THE CITY OF KEY WEST
3140 Flagler St,
Key West, Florida 33040

ADDENDUM #2
Public Transit Facility
Request for Proposal: 001-13
4 October 2012

Questions and Clarifications
CITY OF KEY WEST
Public Transportation Facility Project
Addendum No. 2
October 4, 2012

FIGURE
 3-2

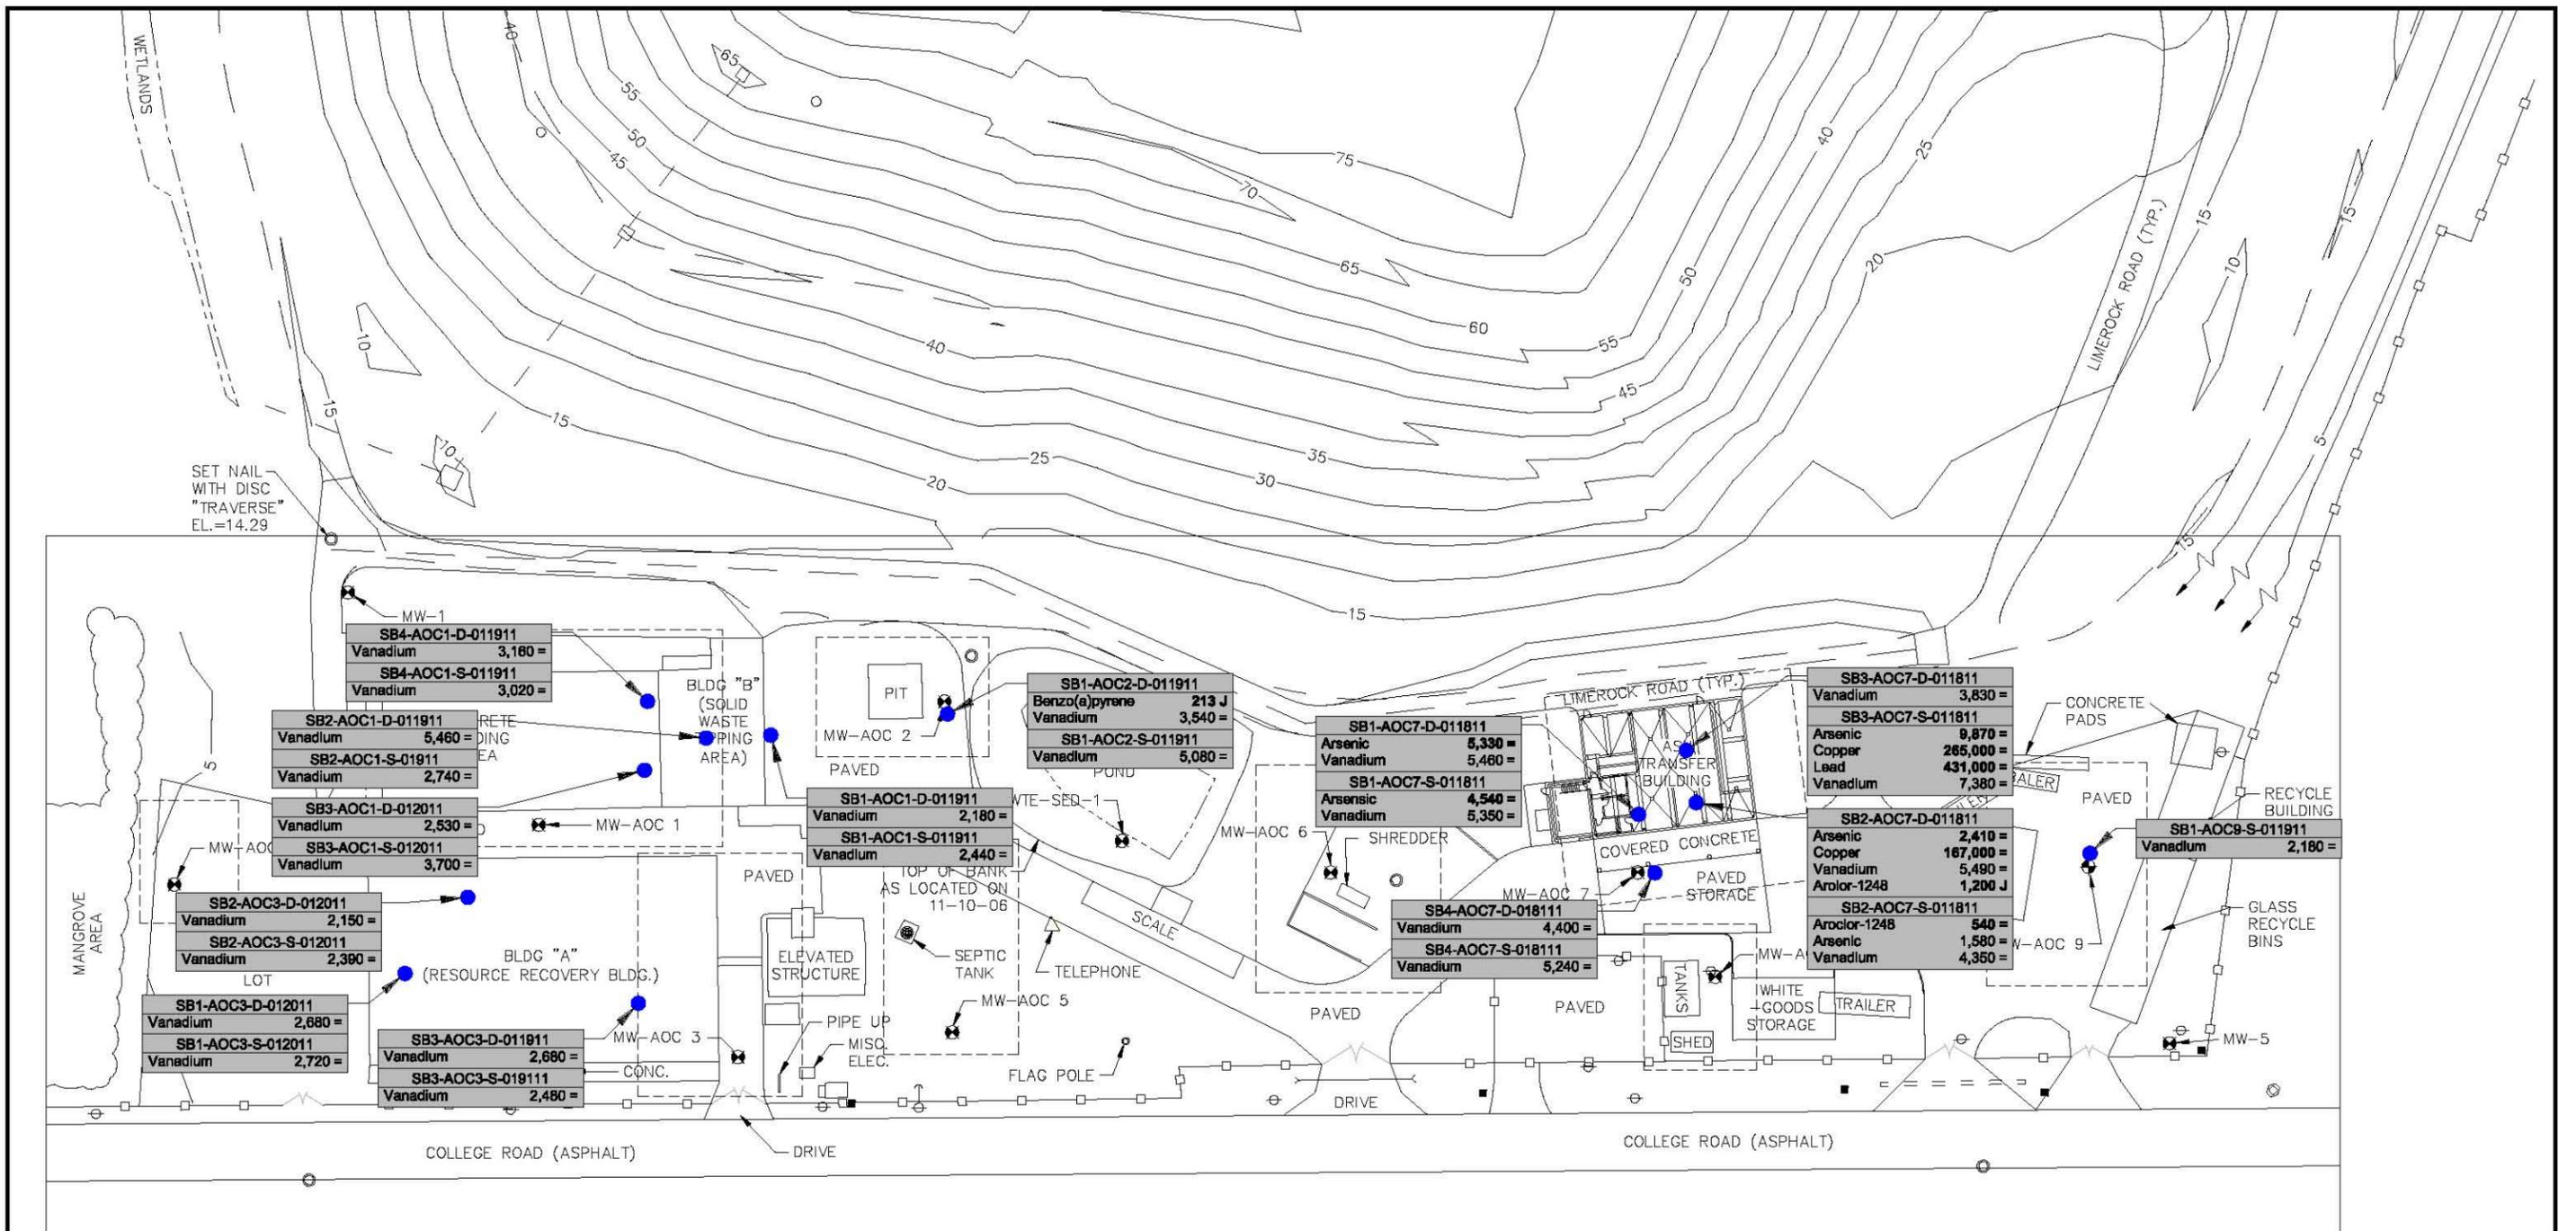
Additionally, the City agrees to add to our current well monitoring status on a bi-annual basis - well #7 (MW-AOC) as noted on the newly revised print attached herein as Attachment #1 / Figure 3-2 / REVISED 9-6-2011. And the City will assure that "Thallium" be added to the test parameters on all wells moving forward and beginning with the bi-annual tests scheduled to be done in December, 2011.
